**Re AUSTRALIAN MUSEUM – ALTERATIONS & ADDITIONS  
SSD 9452  
REVISED DESIGN STATEMENT**

In response to the feedback received from the Government Architect on the 18<sup>th</sup> December 2018 regarding SSD 9452 for the Australian Museum – Alterations & Additions the design team has completed a review of the feedback with the Museum to address the key points raised. The key changes following the SSD submission on the 11<sup>th</sup> August 2018 are detailed below. Please read these in conjunction with the updated drawings, reports and submissions table.

# GROUND

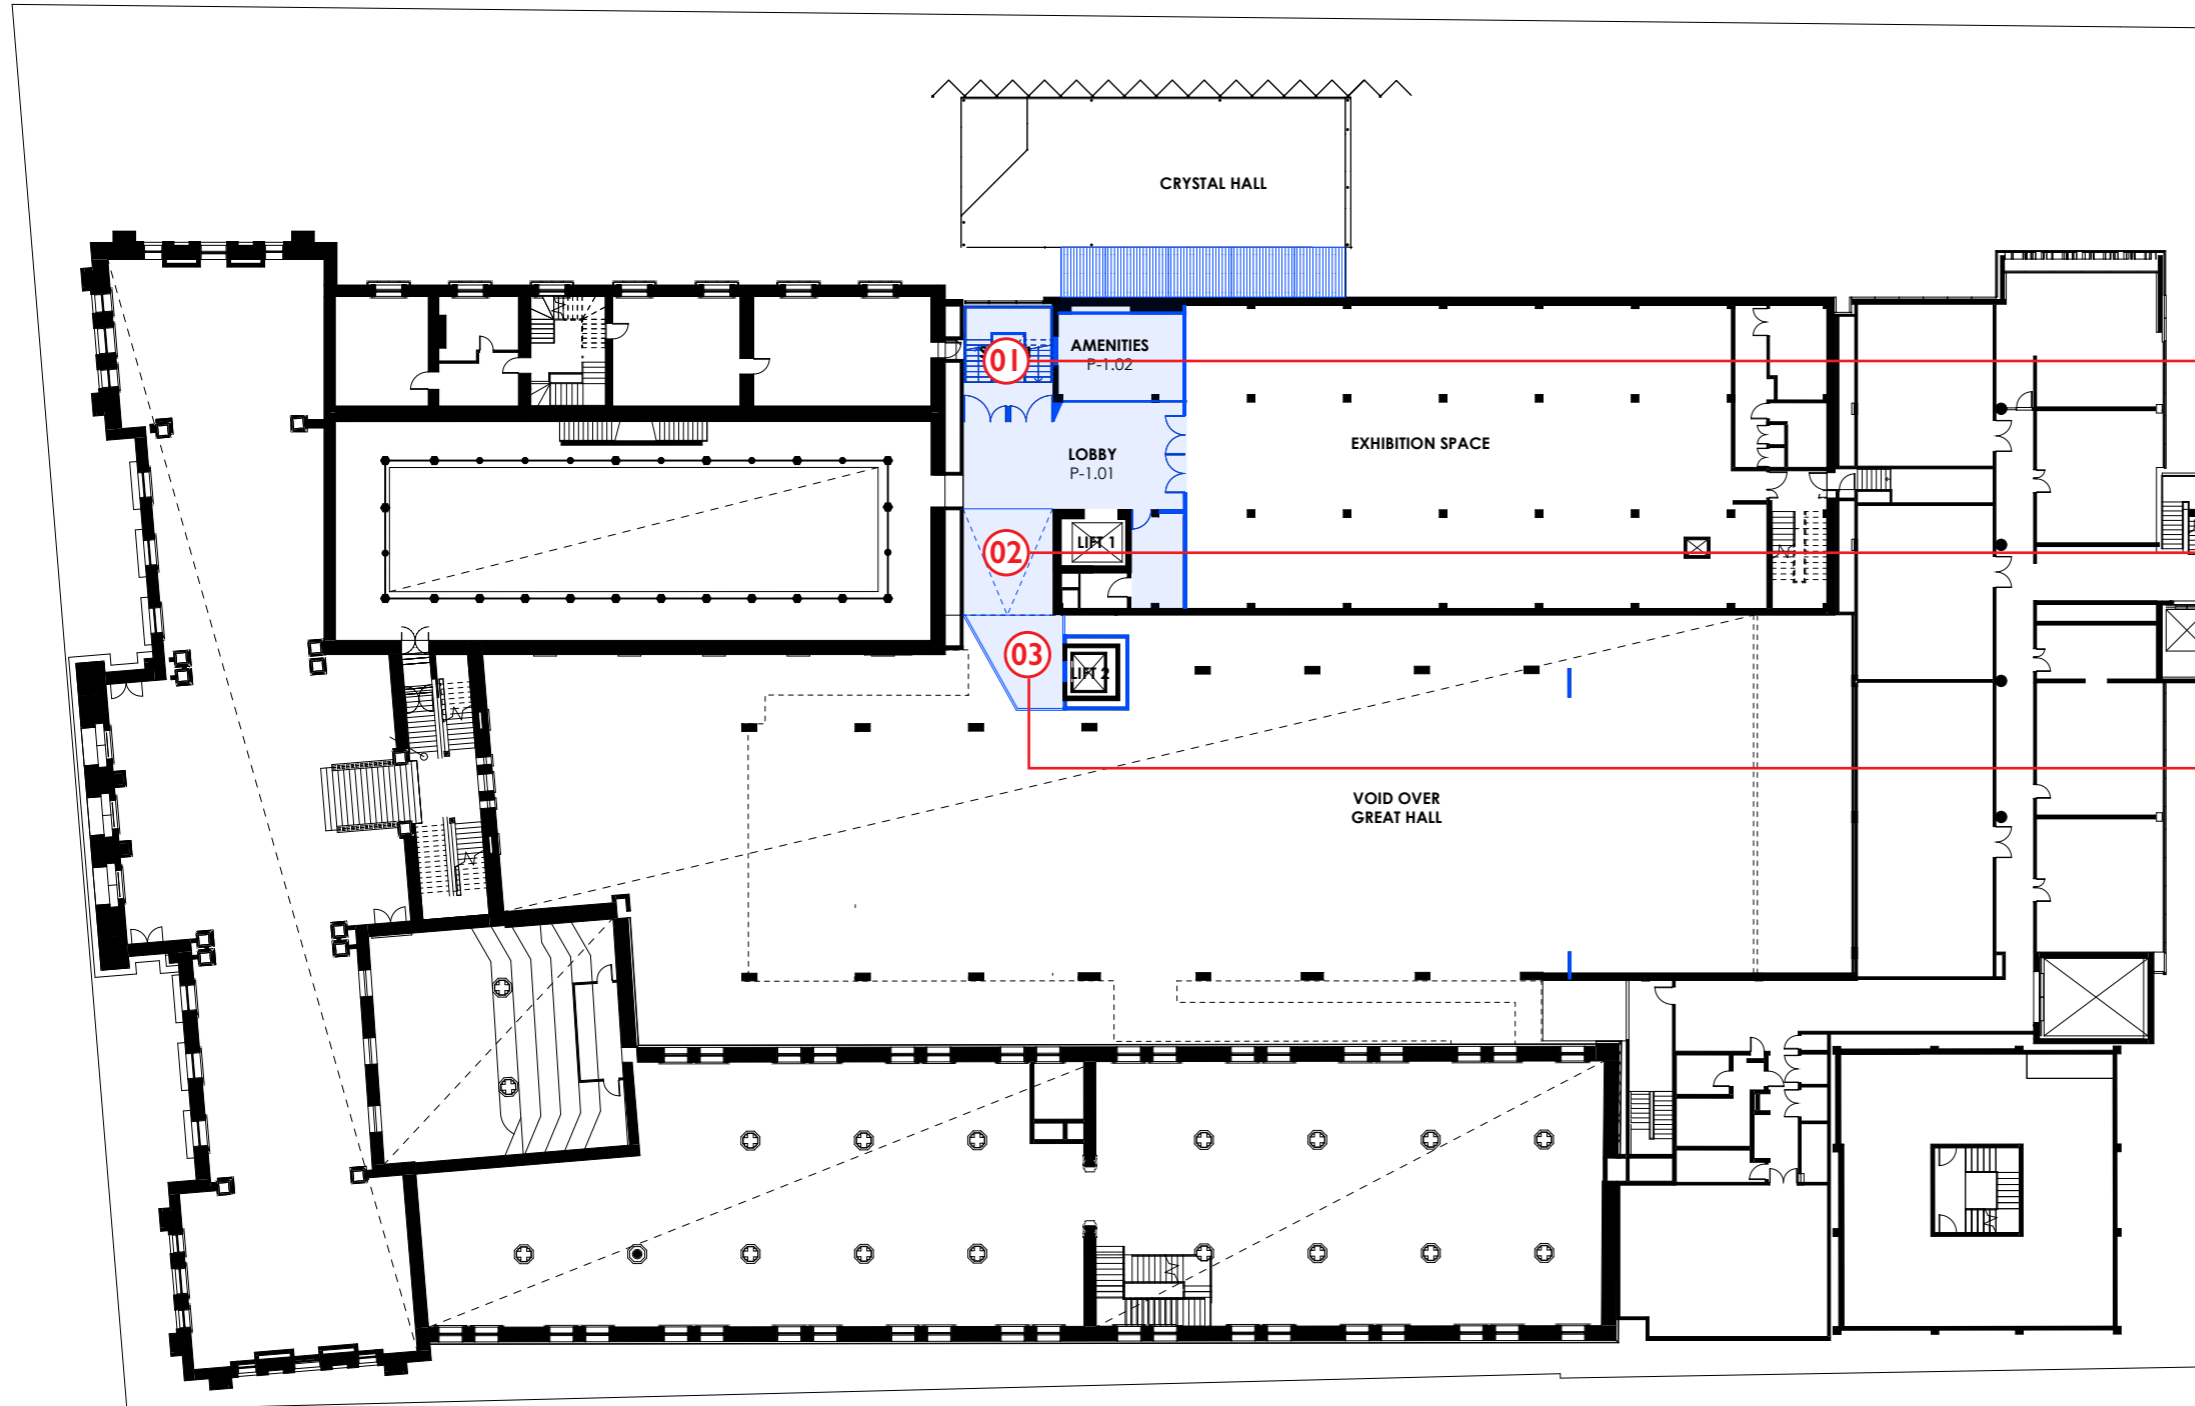
- NEW STAIR RELOCATED TO GLAZED LINK
- DEMOLISH LEVEL I SLAB + CONSTRUCT NEW RAMP TO LIFT LANDING TO ACHIEVE HEAD HEIGHT TO GROUND LEVEL BELOW
- CONSTRUCT NEW LANDING AND BALUSTRADE. LIFT 2 STOPS AT LEVEL I

# LEVEL I

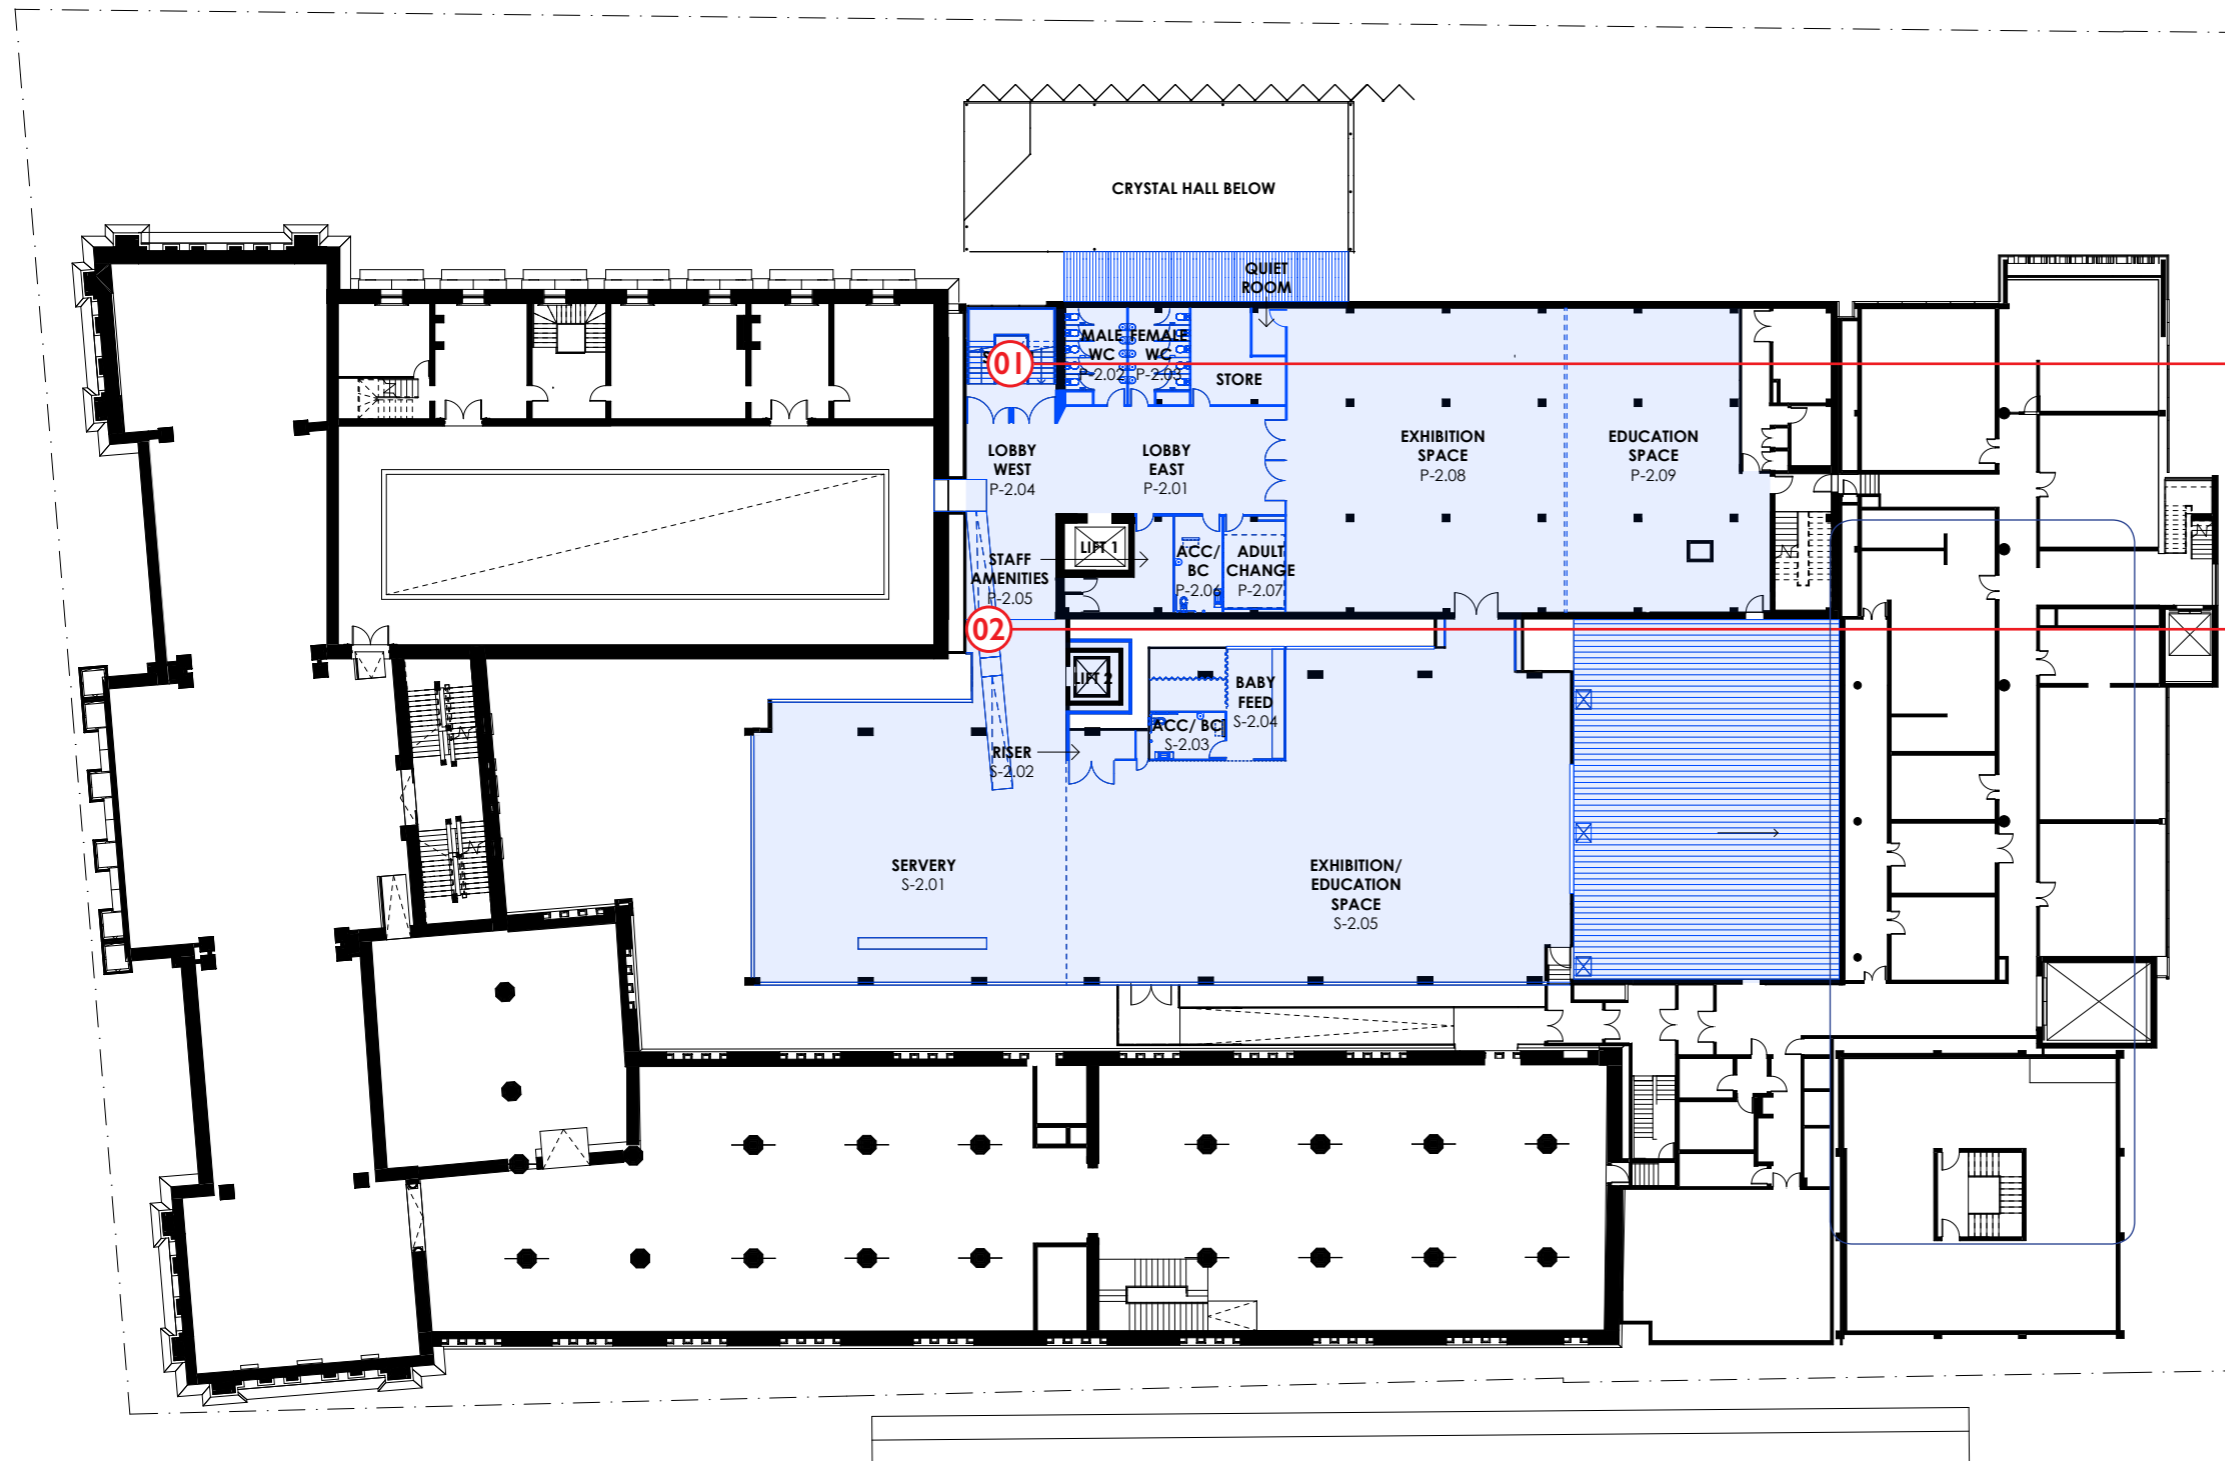
NEW STAIR RELOCATED TO GLAZED LINK

NEW RAMP TO PROVIDE ACCESS UP TO THE LEWIS WING (REFER ALSO OPTION 2 + 3)

# LEVEL 2

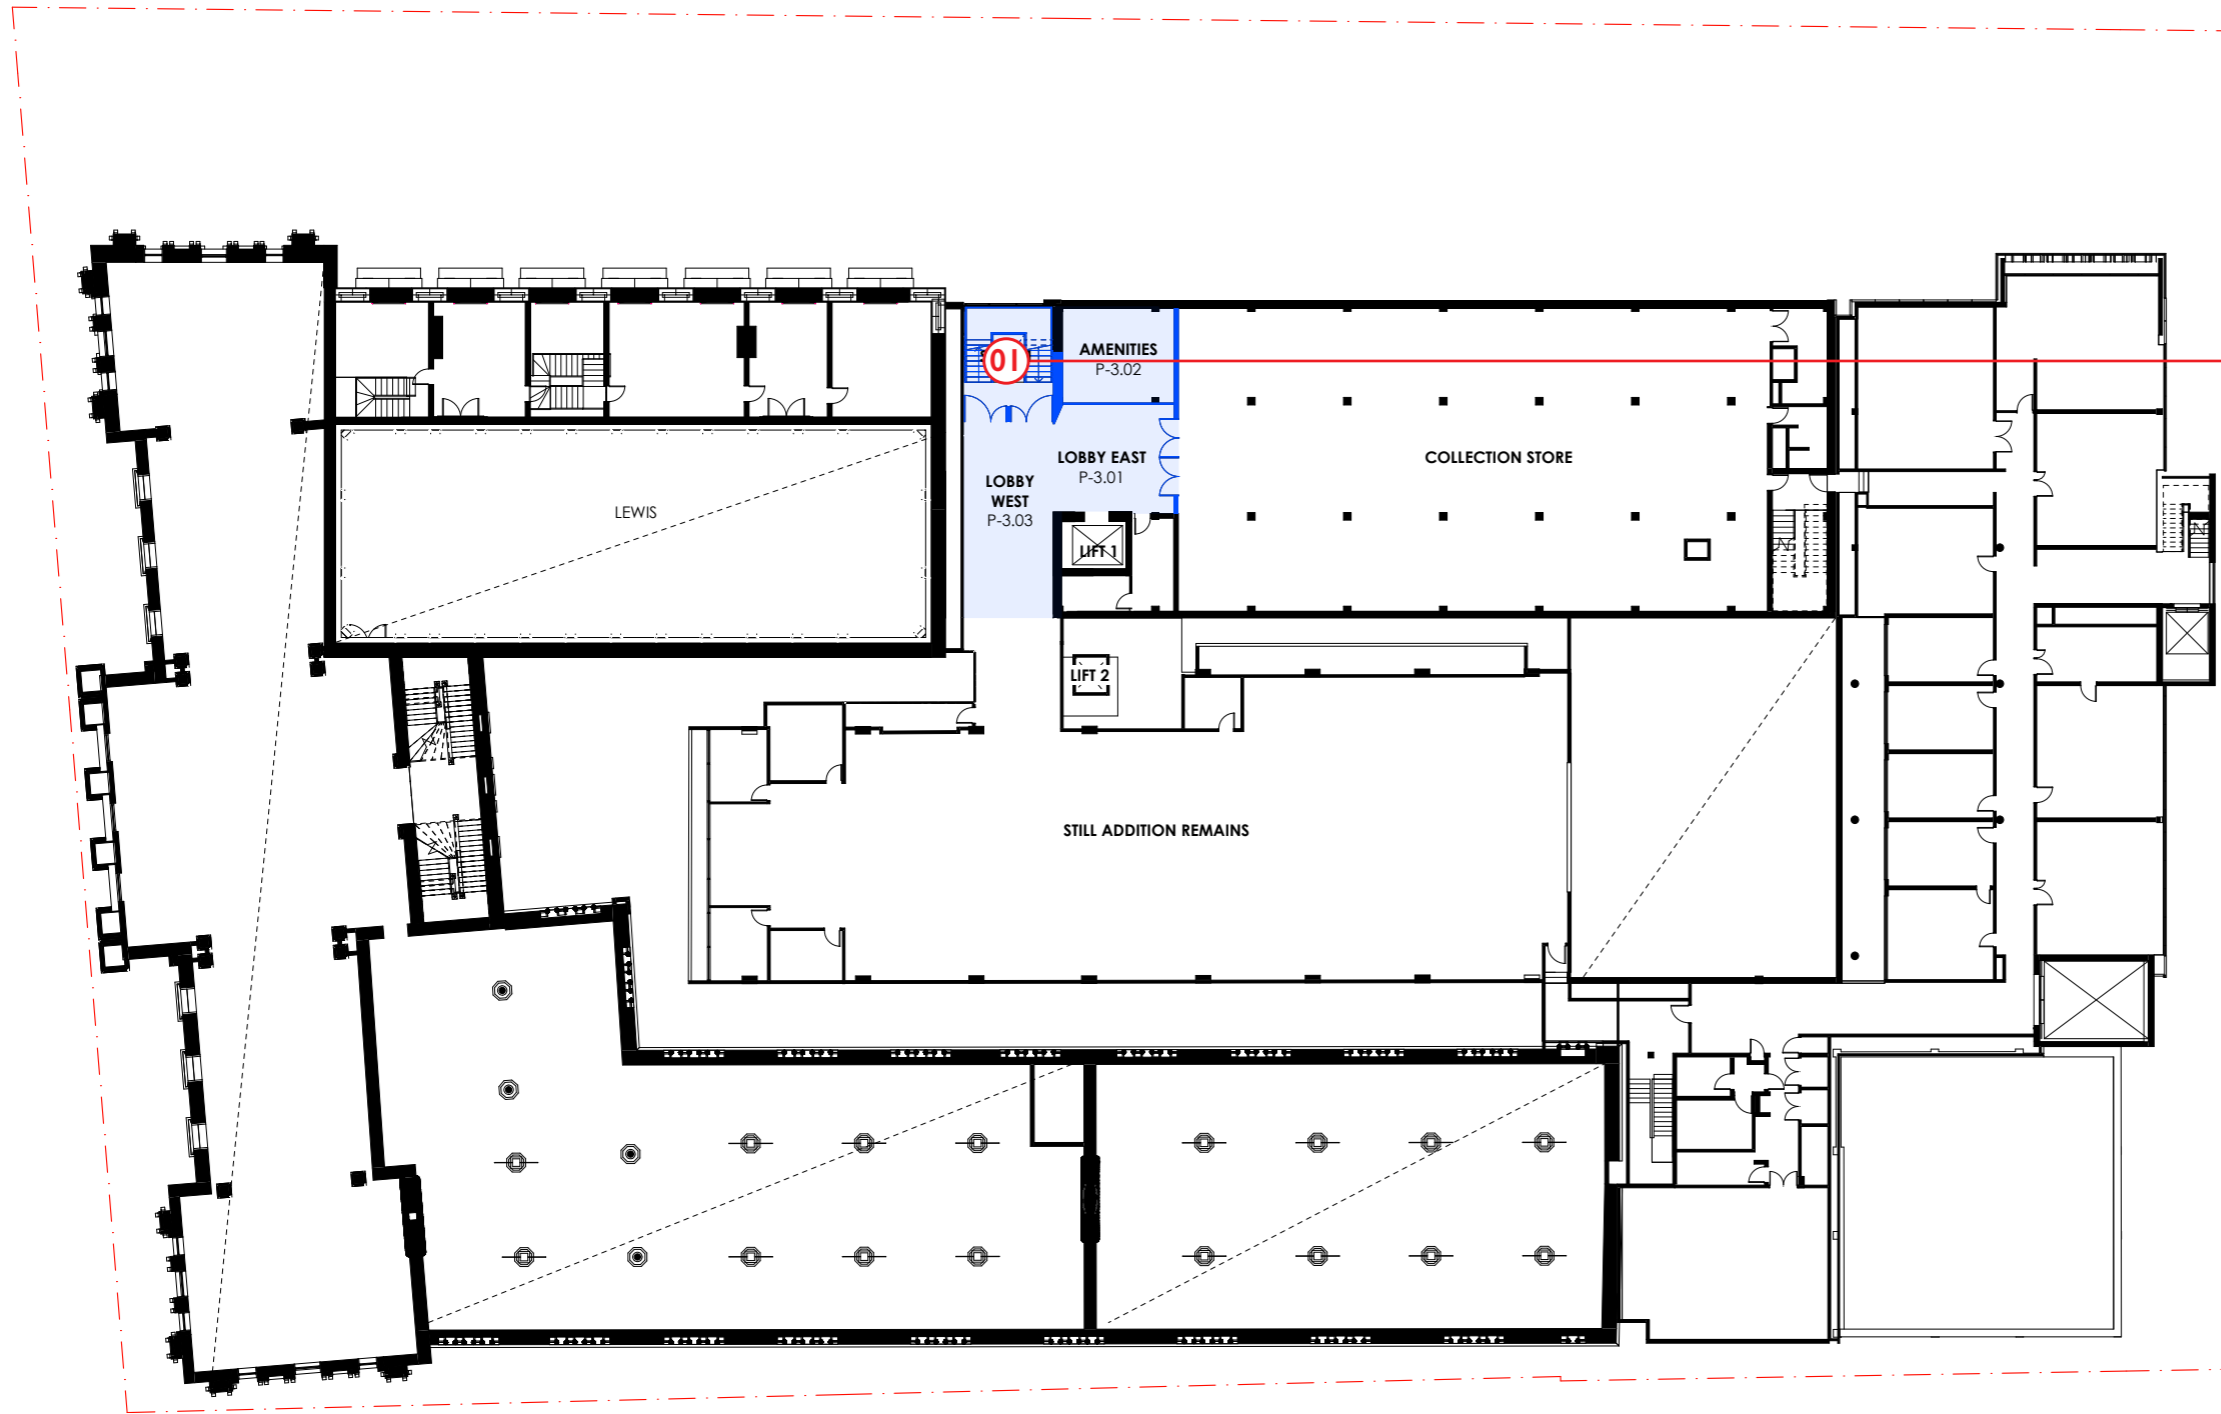
NEW STAIR RELOCATED TO GLAZED LINK
